HORSHAM DISTRICT COUNCIL CONSULTATION

TO:	Horsham District Council – Planning Dept
LOCATION:	Land East of Tilletts Lane Warnham
DESCRIPTION:	Erection of 59 dwellings with associated open space, landscaping, parking, access, and drainage infrastructure.
REFERENCE:	DC/25/1155
RECOMMENDATION:	Advice / Modification / Holding Objection to the current position of the access road within the RPA of T59, and the foreseeable impact this will have on the tree's viability for long term retention.
SUMMARY OF COMMENTS & RECOMMENDATION: The application has been supported by a detailed Arboricultural Impact Assessment and Preliminary Methods Statement, and a Tree Protection Plan, however, concerns are raised with the site access and the foreseeable impact this will have on the off-site Oak T59 with regards to tree's viability for successful long-term retention.

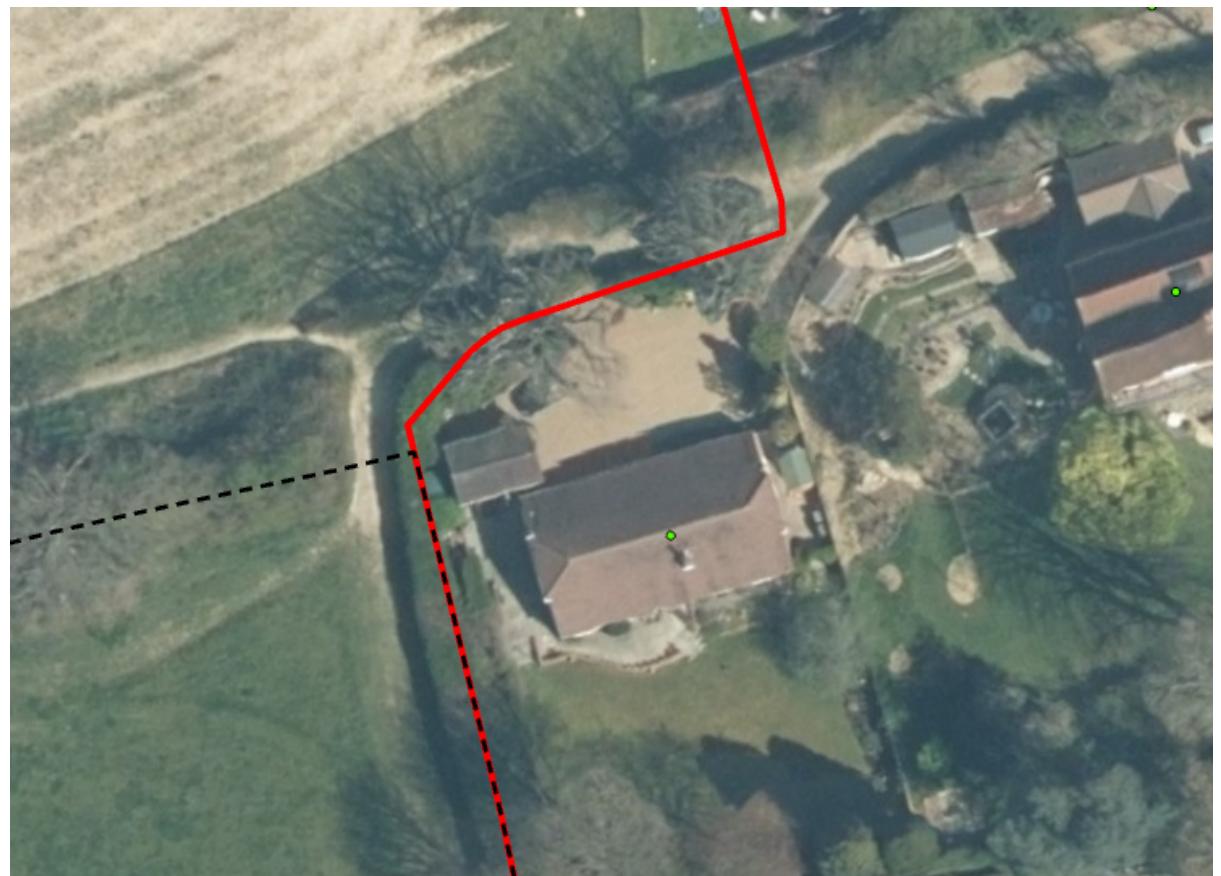
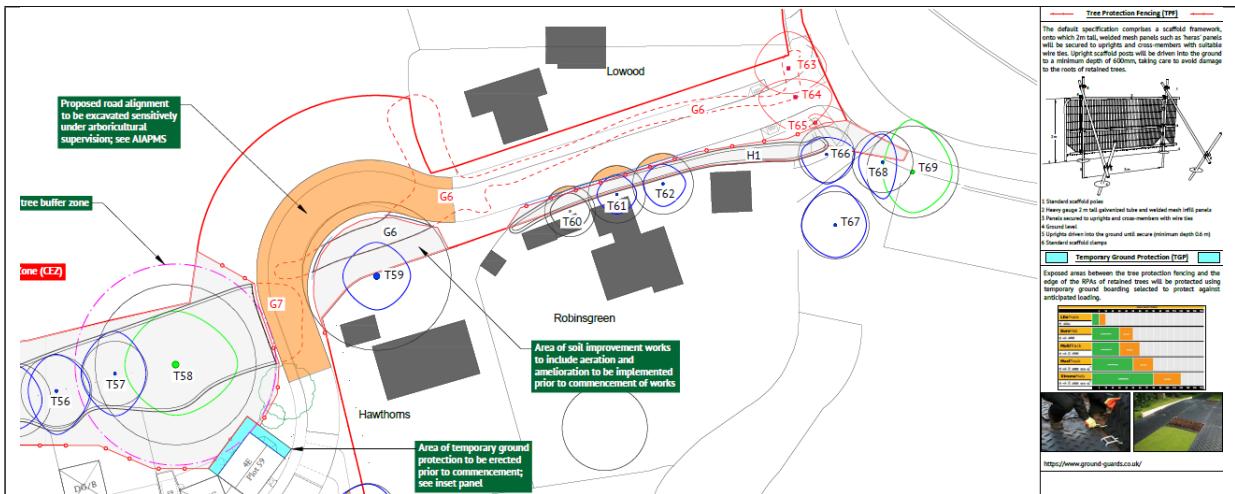
My primary RPA concern is with the proposed access road, which extends into the RPA of T59, a mature Category B2 English Oak located within the curtilage of Hawthorns, Knob Hill, Warnham, and just within a designated Conservation Area. The tree is readily visible to users of the PROW to the north, and despite being subject to fairly robust pruning works, it still makes a positive contribution to the character and amenities of the locality.

The area immediately south of T59 is occupied by the property's principal parking area and garage. The tree sits on slightly elevated ground relative to this area, possibly due to excavation works undertaken to create a level surface at the time of property construction. The parking area is predominantly surfaced with shingle, please see below

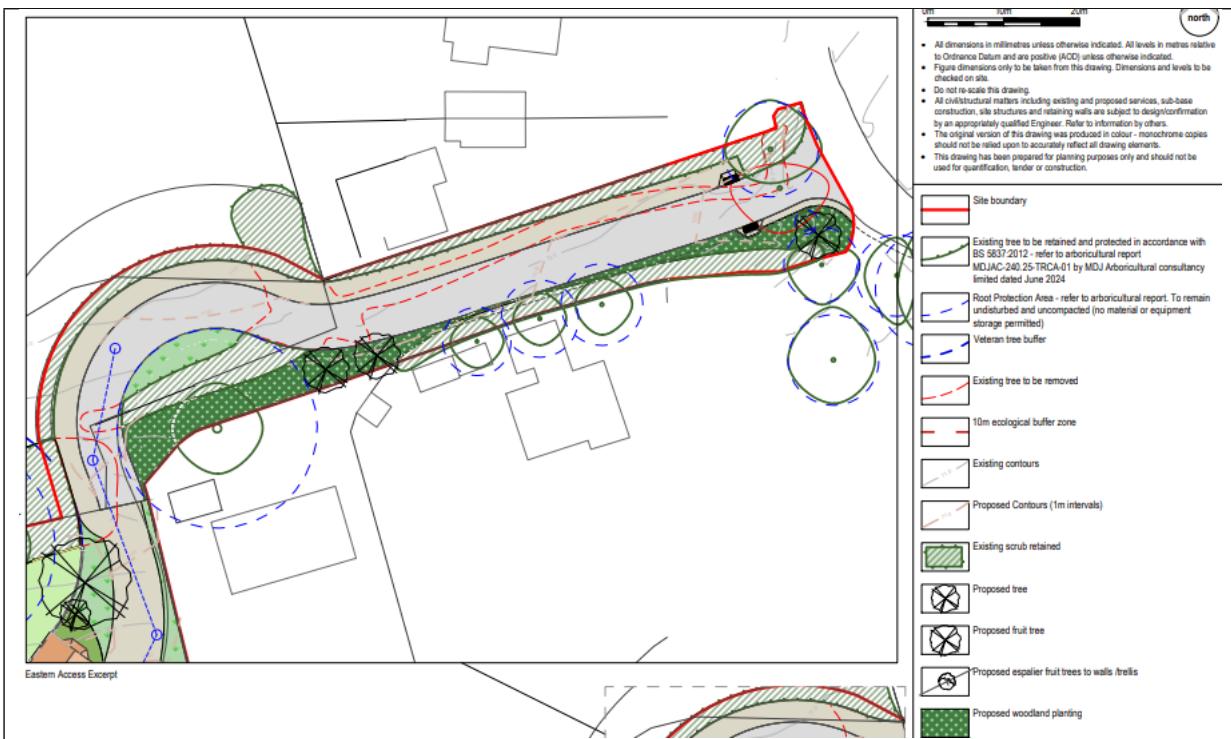
Due to the constraint posed by the change in land levels and the parking area to the south of T59, it would imply that the tree’s principal rooting area lies to its north, beneath the compacted trackway/PROW, where the new site access is shown. Whereby, the long-standing parking area to the south has most likely impeded any significant root development in that direction and, in itself, constitutes a significant proportion of hard surfacing within T59’s RPA, as indicated on the Tree Protection Plan. When combined with the proposed 8.8% incursion, the cumulative extent of hard surfacing within the RPA would exceed the tolerable limits of 20%, as advised in the BS.

As such, even with the proposed mitigation, the excavation required for the road would almost certainly result in the loss of a significant proportion of T59’s key rooting area and rooting volume. This action would be detrimental to the trees health and compromise its long-term retention potential.

Furthermore, the proposed drainage strategy indicates that underground services requiring open trenches would also fall within T59’s RPA, as with the building of the road, this action and the root severance that it would entail have the capacity to significantly impact T59’s condition and long-term retention potential and is unsatisfactory.
